Work Order ID 85563

Item Name: Crosstube Aft

From: David Shepherd <dshepherd@dartaero.com>
Sent: Monday, July 30, 2012 5:29 PM
To: 'Eric Downing'; 'Alex Pharand'
Cc: 'Mike Petsche'; psmith@dartaero.com
Subject: RE: D212-664-201 crushing

DART AEROSPACE LTD		Work Order:	85563
Description: Crosstube High Aft (205/212)		Part Number:	D212-664-201
Inspection Dwg: D212-664-241 Rev: D		Page 1 of 1

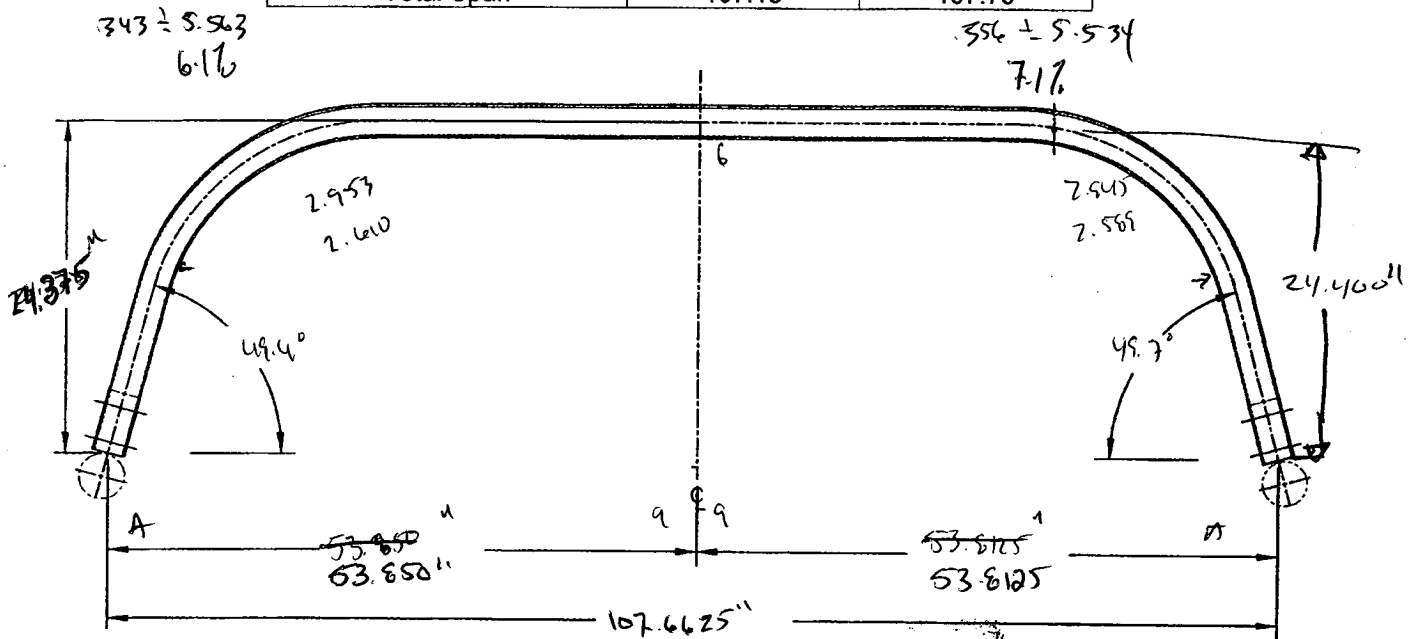
I have a D212-664-201 cross tube with the crushing out of drawing tolerance.

As you can see in the attachment that **side A** has a crushing of **6.1% at 9 passes** and **side B** has a crushing of **7.1% at 9 passes**. They were both measured at about 16" from cuffs.

Is this acceptable?

Comments
Since A = 6.1% crushing @ 9 Passes
Side B = 7.1% crushing @ 9 Passes
Middle = 6 Passes

This deviation is acceptable.

D212-664-241/-241B
ASSEMBLY DETAIL

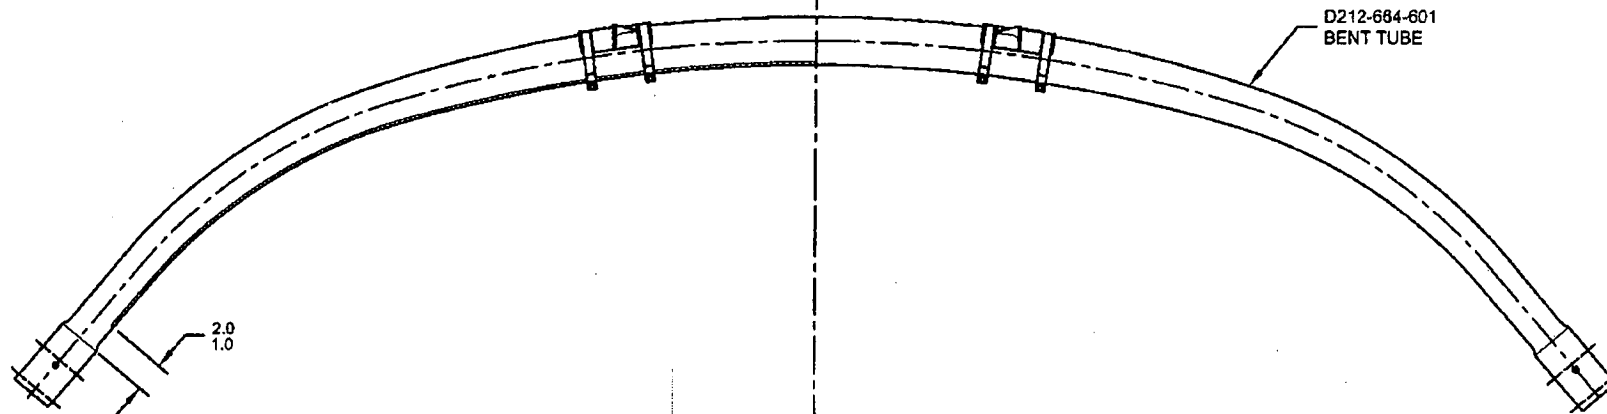
ADD AN INSPECTION WINDOW TO UNDERSIDE OF CROSSTUBE.

- 2) FINISH: CHEMICAL CONVERSION COAT PER DART QSI 005 4.1
PRIME INSIDE AND OUTSIDE PER DART QSI 005 4.2
MASK UNDERSIDE OF CROSSTUBE AS SHOWN (HATCHED AREA) AND
PAINT OUTSIDE PER DART QSI 005 4.2
REMOVE MASKING AND APPLY CLEAR COAT

MASK AREA PRIOR TO PAINTING,
REMOVE MASKING AFTER PAINT
AND APPLY CLEAR COAT
